PROJECT TITLE: TRACT IV ZONE ATLAS/DRNG. FILE #: H9 / 6-9 / 0102

RE: GRADING & DRAINAGE PLAN FOR TRACT IV, PHASE I, MONUMENT POINTE,
LAURELWOOD SUBDIVISION, SUBMITTED 16 DECEMBER 1988, FOR
PRELIMINARY PLAT APPROVAL (H-9/D1D2)

DRAINAGE PLAN FOR
TRACT IV, PHASE I
"MONUMENT POINTE"
LAURELWOOD II SUBDIVISION

MONUMENT POINTE GRADING & DRAINAGE PLAN

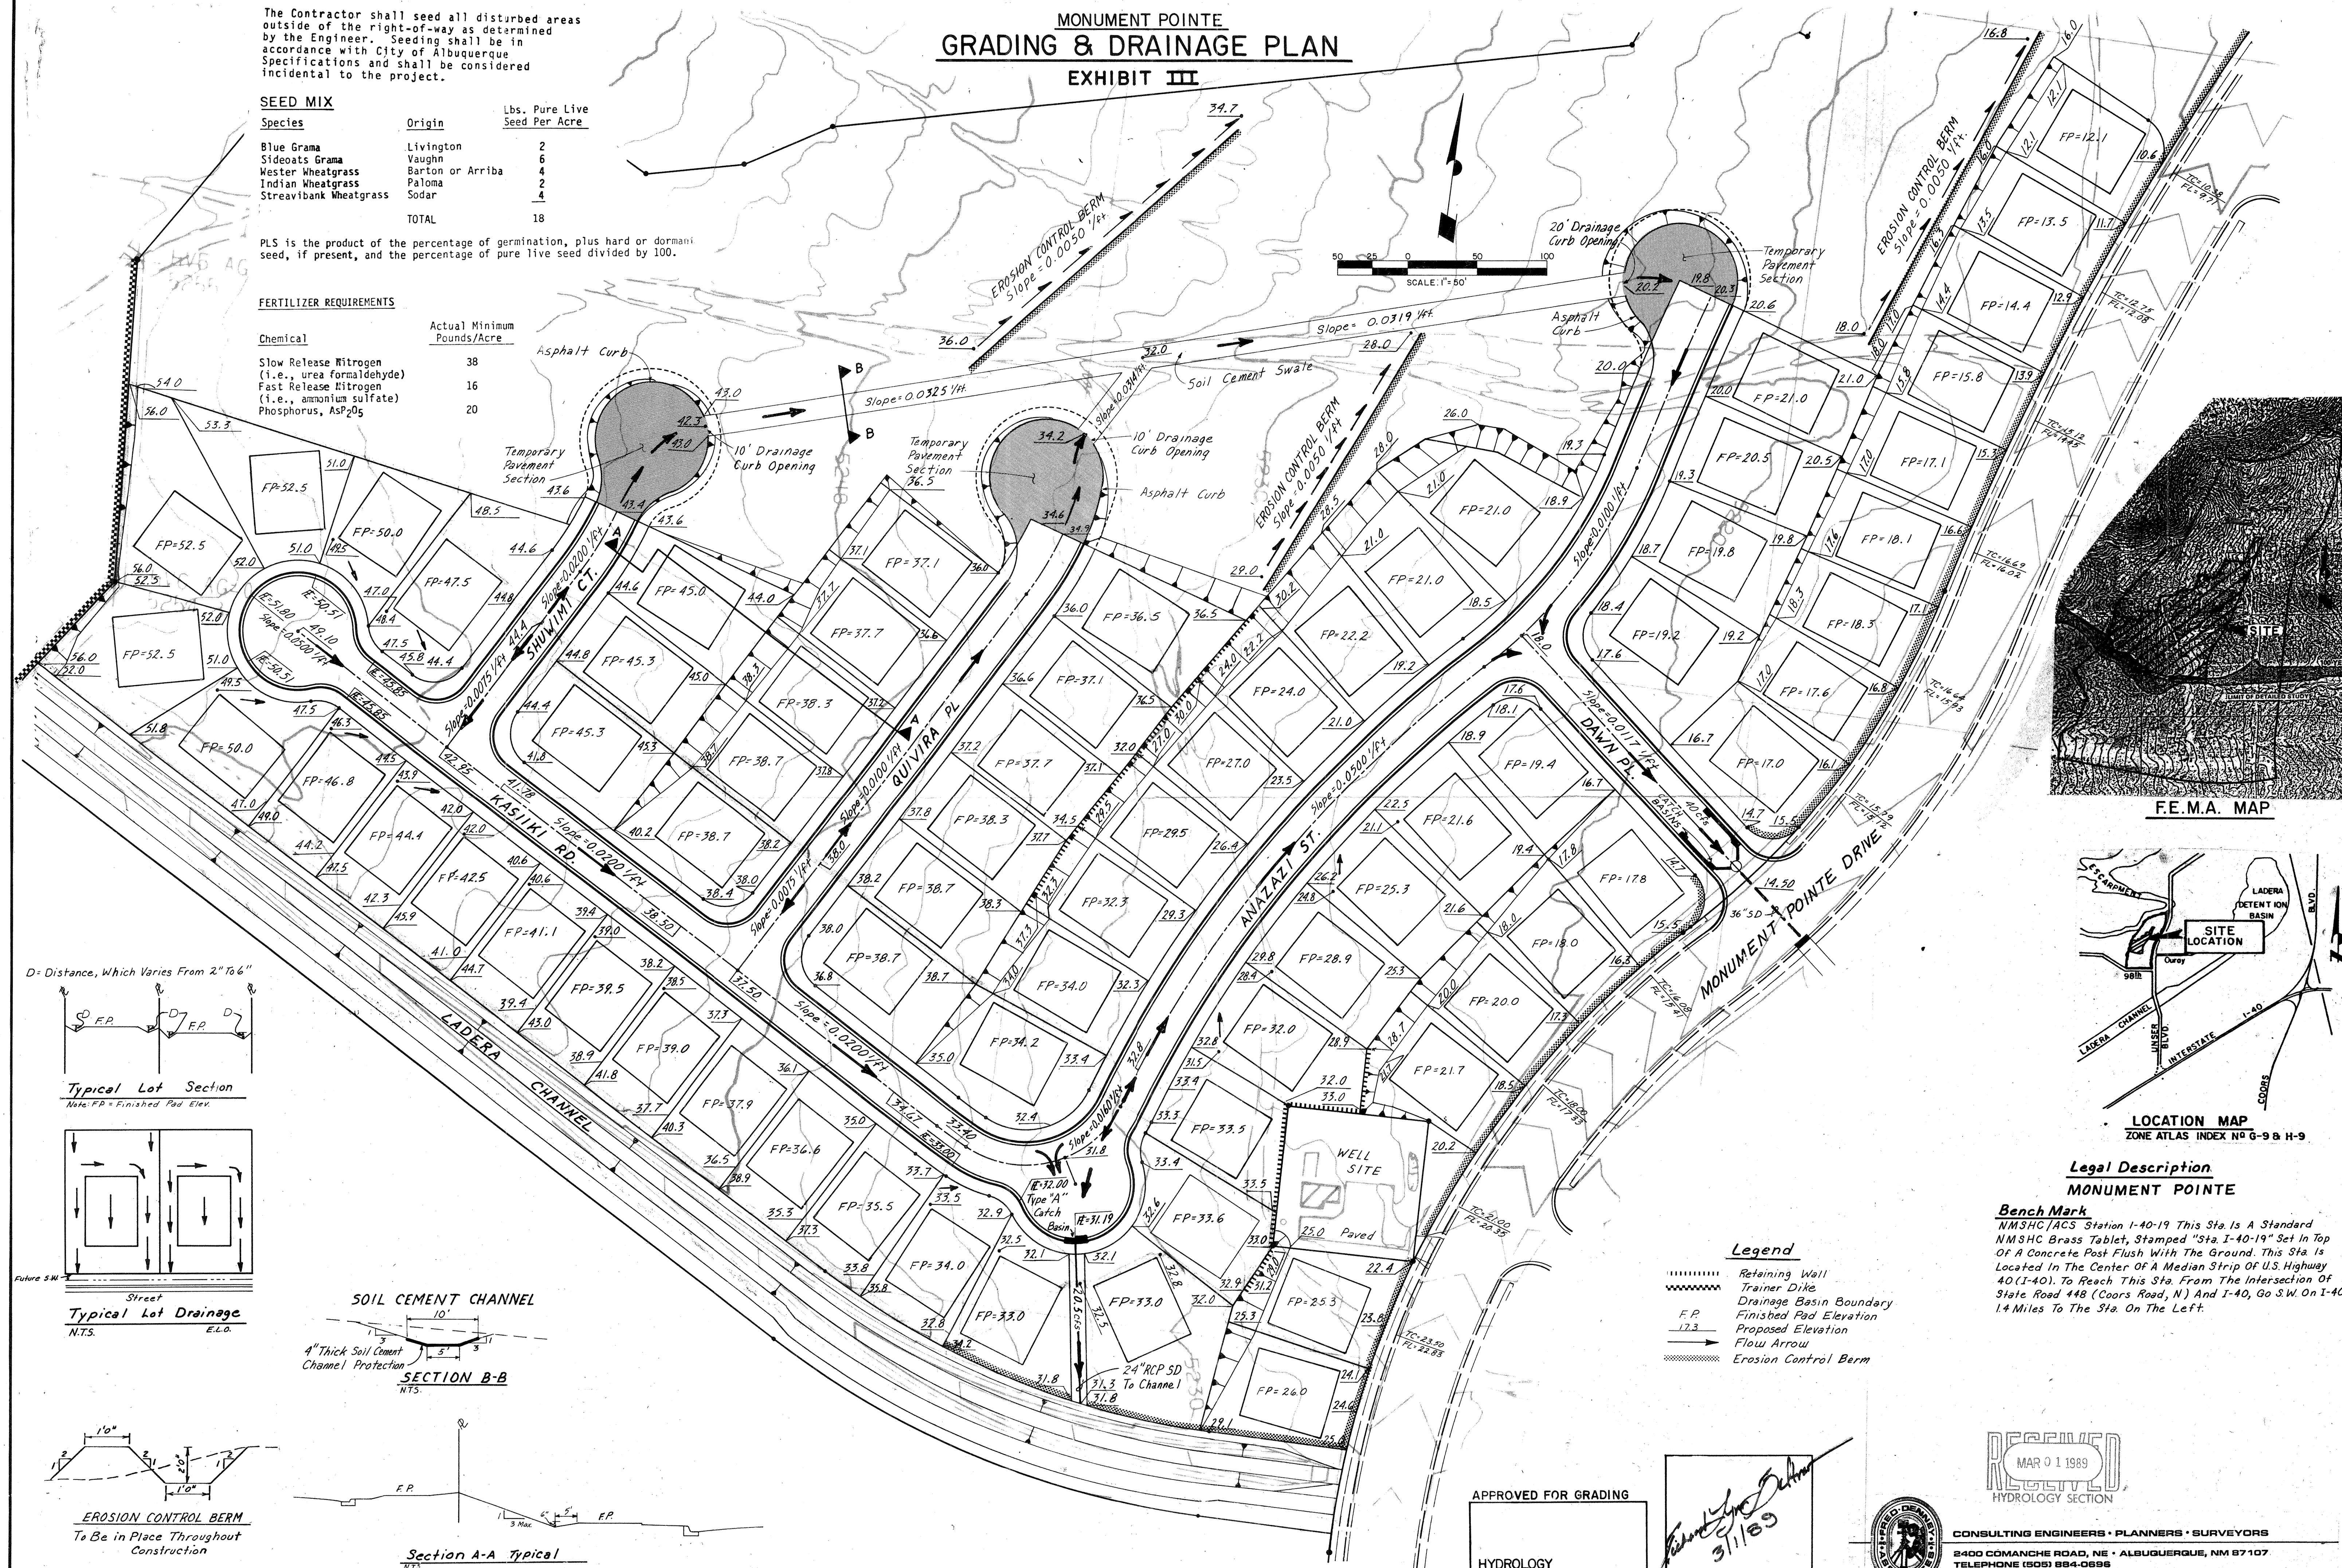
1. The interim swale from Shuwimi Place to Anazazi Place which serves Subbasin 6, has a Froude number of 1.06. By DPM criterion, this number must be less than 0.7 or greater than 1.3, so that the flow is either clearly supercritical or clearly subcritical.
2. Please provide some calculations for the ponding volume required at the west property line for the entrance to the hardlined Ladera Channel, so that we may agree that the area within the easement granted by Westland Development Co. is adequate. The easement provided is being reviewed and comments will be forthcoming.

Basin ⑥ Interim Swale

$$Ff = 1.47 > 1.3$$

\therefore Flow is strongly supercritical!
